*Petroleum-Contaminated Soil Removal
Lake Washington Ship Canal
Seattle, Washington*

*Prepared for
Seattle District
U.S. Army Corps of Engineers
and Jacobson Terminals, Inc.*

Corps Contract No. DACW67-96-M-0671

*March 1997
J-4617*

Boring Log and Construction Data for Monitoring Well HC-MW-1

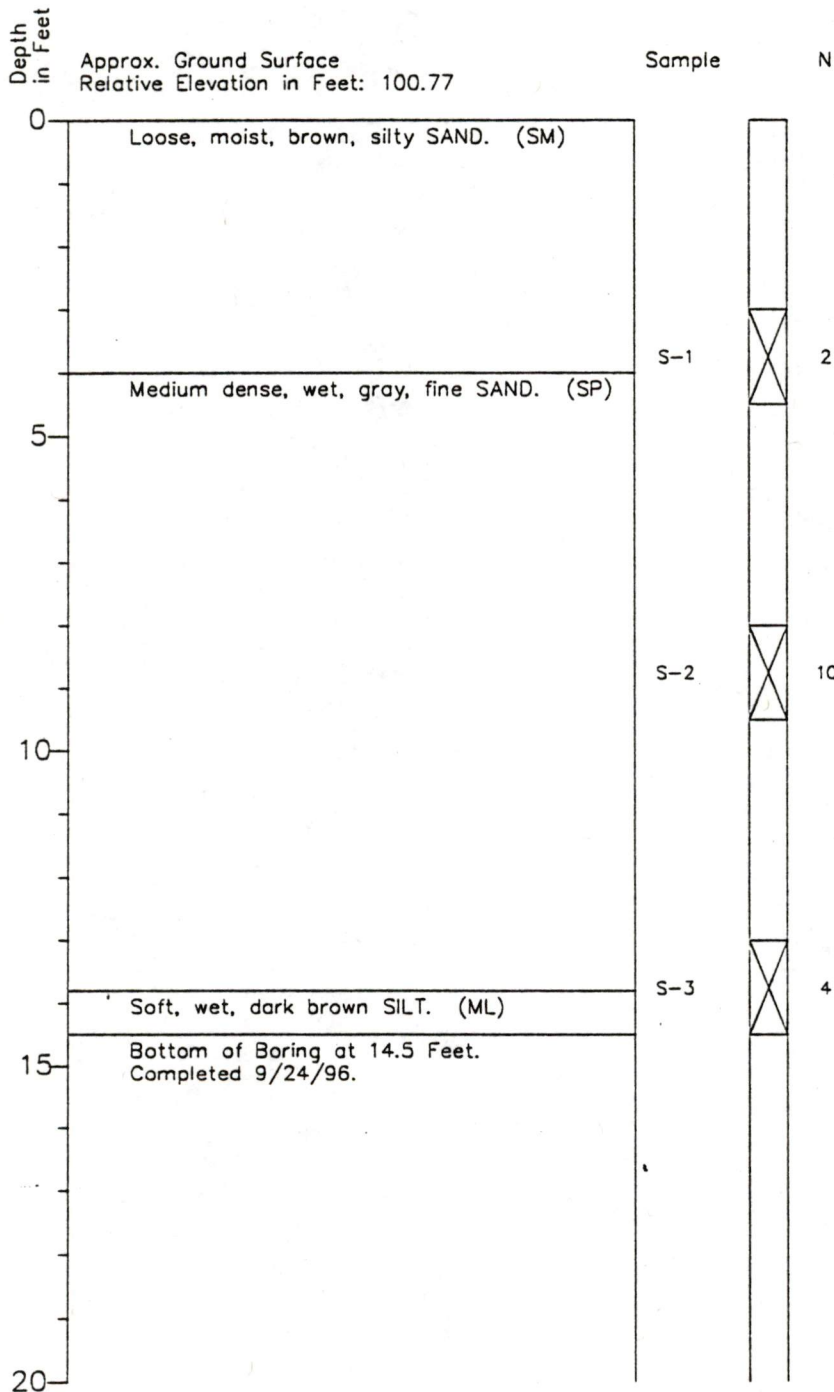
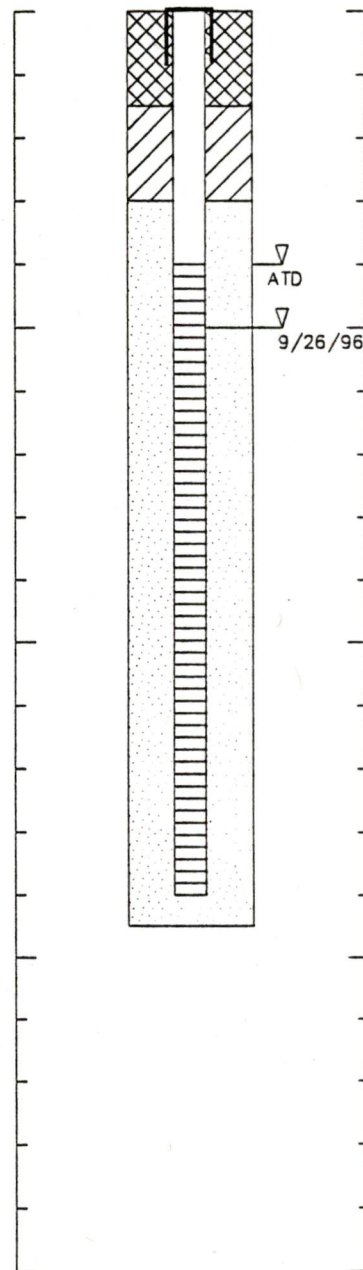
19. Figure A-2 thru A-5. Clarify footnotes 3 and 4.

Boring Log HC-SB-1

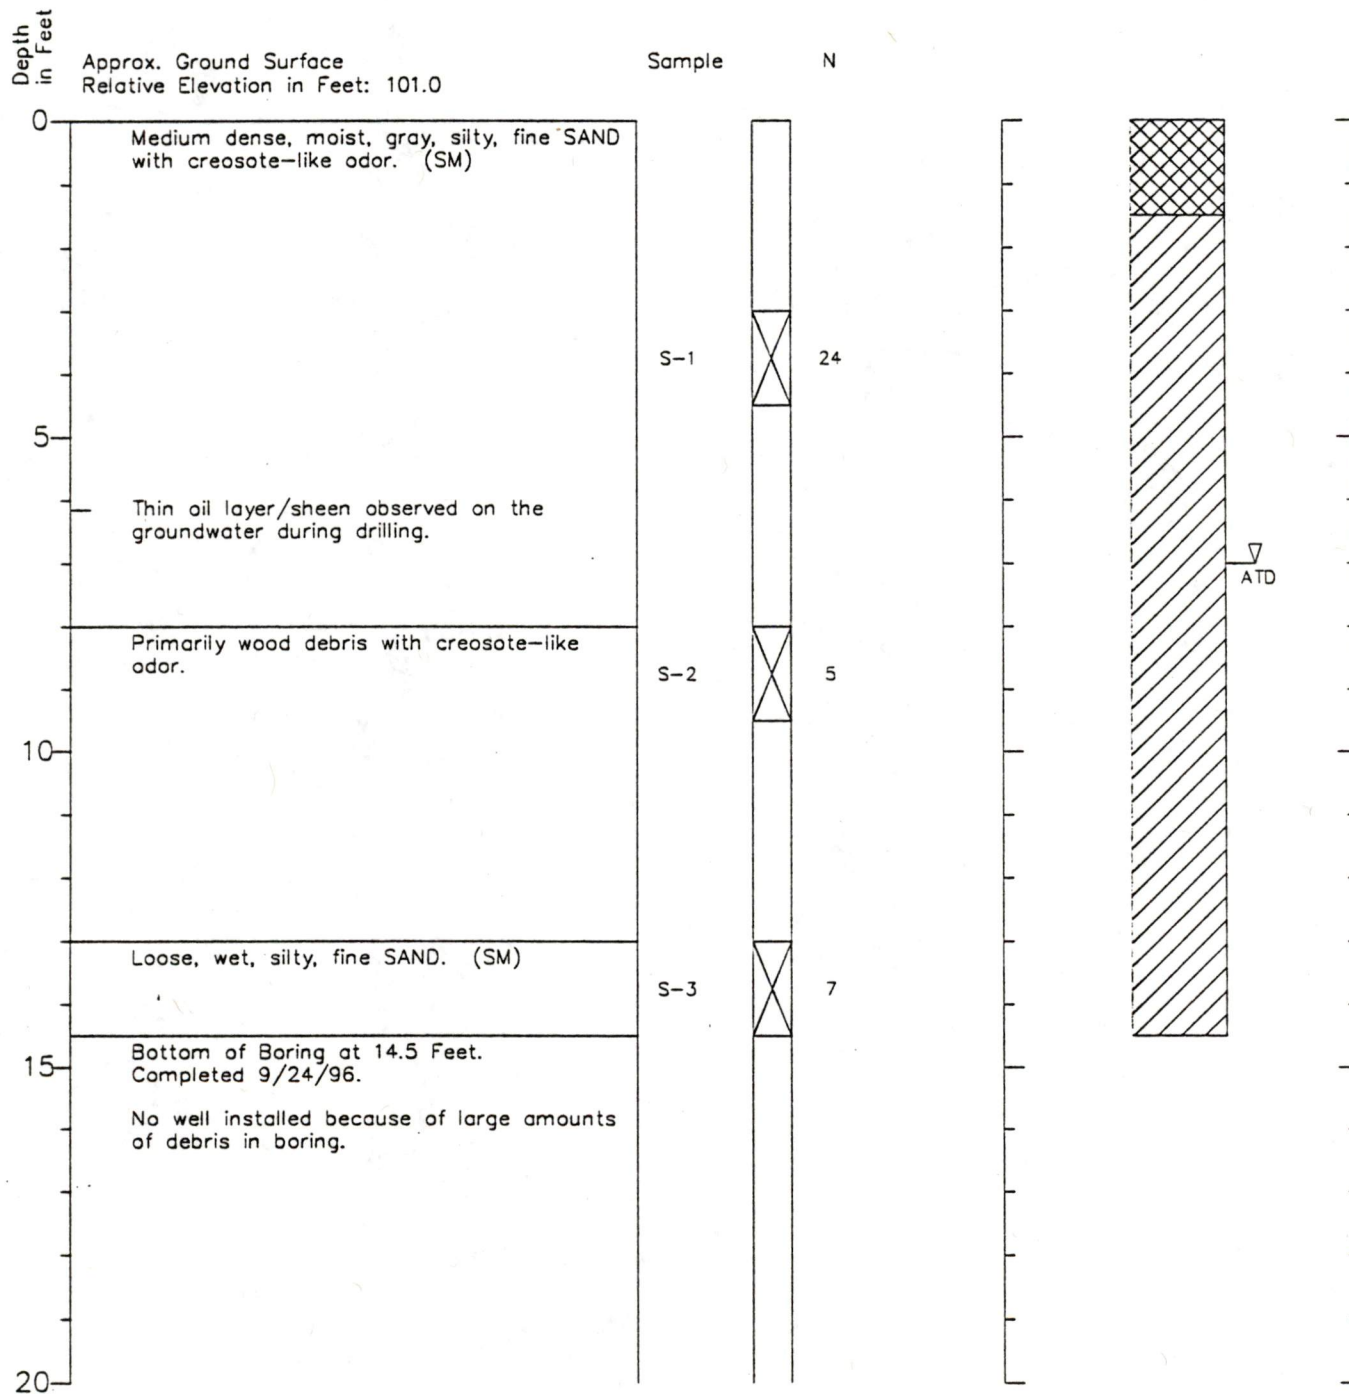
27. Pg. A-4, Borehole abandonment: delete entire first sentence. HC-SP-1 should be changed to HC-SB-1.
28. Pg. A-4, Groundwater sampling, 1st sent.: should read "Groundwater samples were collected... 2nd sent: replace "just" with "immediately". 4th sent: please rewrite.

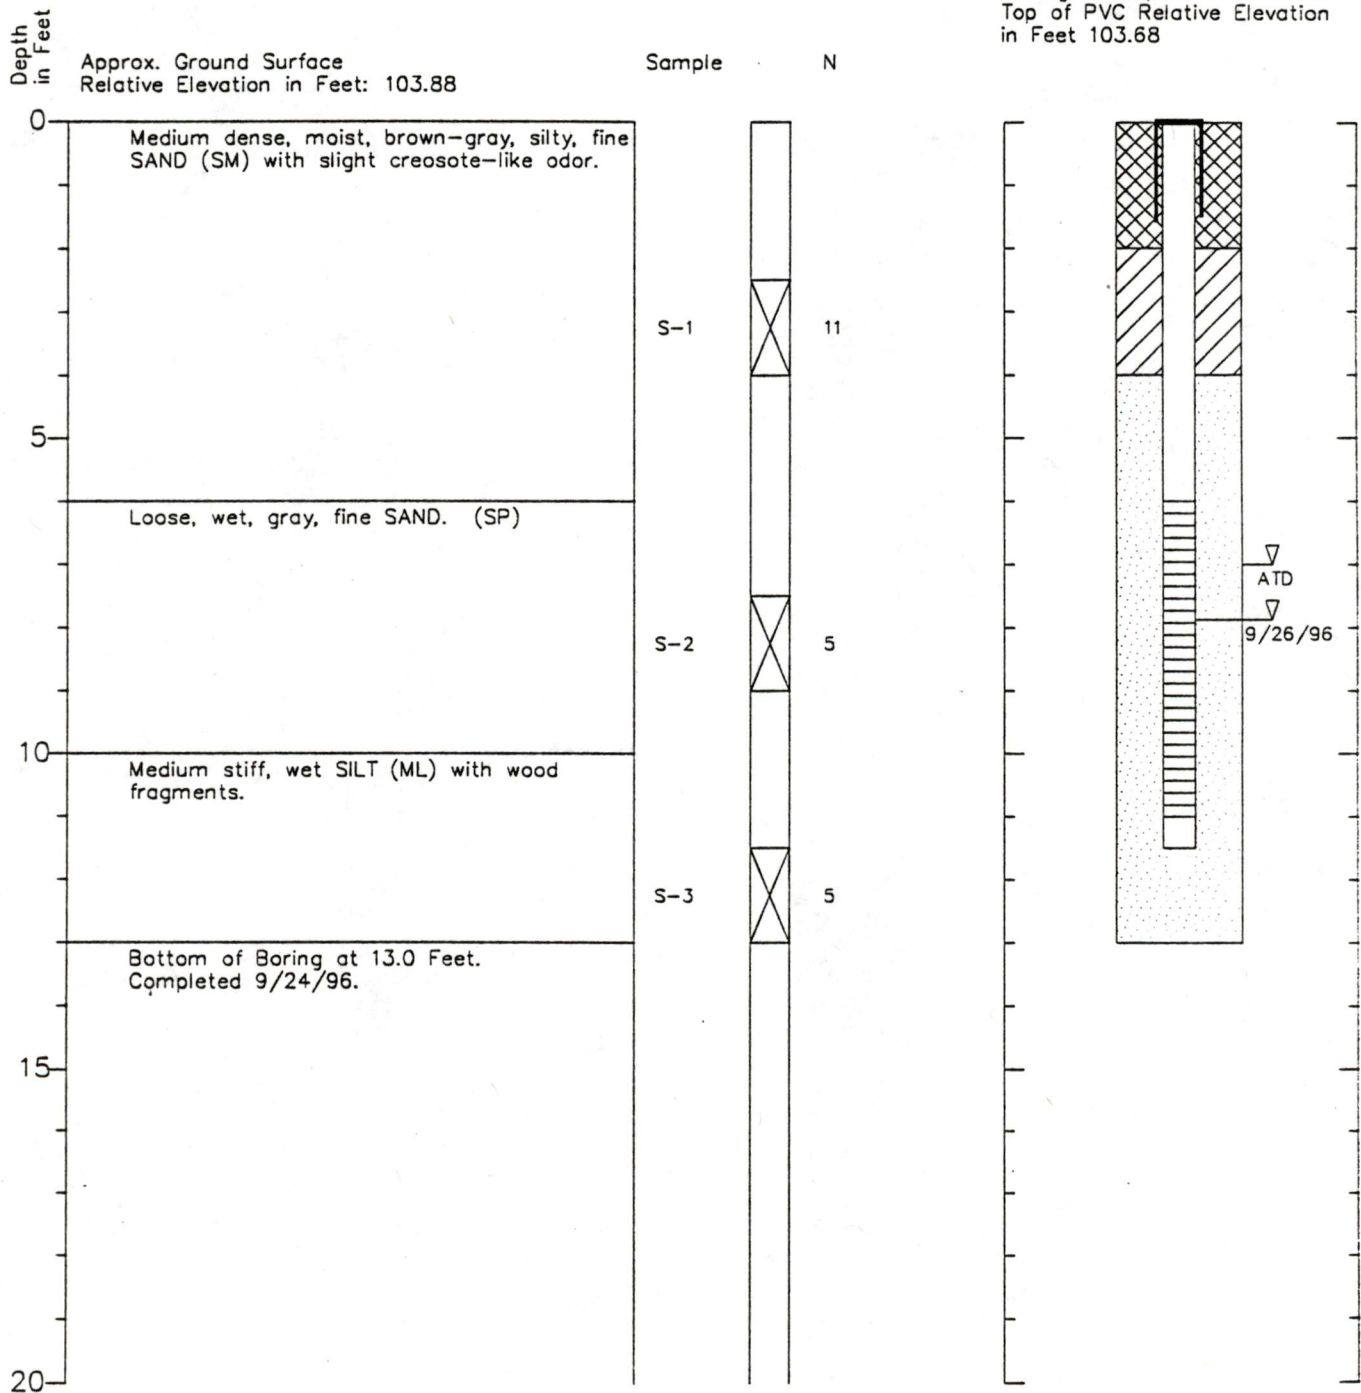
23. Pg. A-3, Well installation and development: this sections says that all three wells have 10 foot screens, but the log shows MW-3 has a 5 foot screen. Also, there is a sentence near the bottom of the page that states that the total volume of development water removed from MW-1 was 9 gallons instead of the calculated 14. What is the relevance of this? If this is significant, the preceding sentence should state that the other 2 wells had 10 volumes removed, not that each well had 10 volumes removed. Does the following sentence (Development was stopped...) pertain to MW-1 only? Please clarify.

MOISTURE-DENSITY RELATIONSHIP TEST

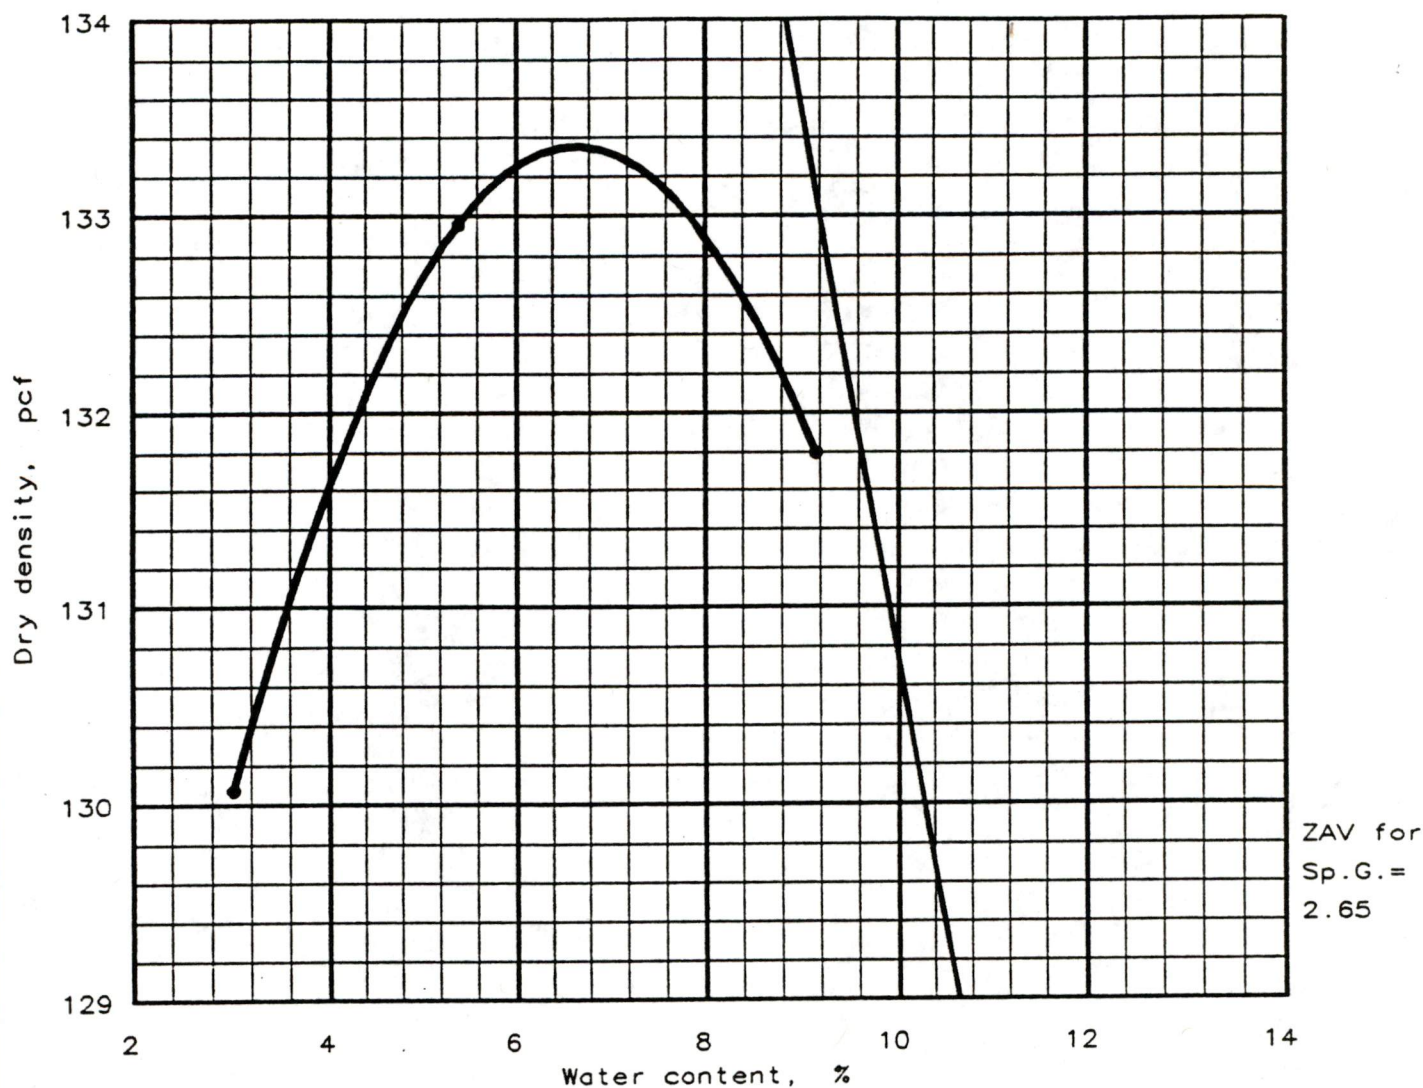
21. Pg. A-1 last pp: is 12-mil correct? Also, were sandbags actually used?
22. Pg. A-3 top of page: says both tests passed the compaction criteria of 95%, while section 2.2 says the results were 94% and 95%. Does the 94% result pass the 95% criteria because of error calculations? Please explain.
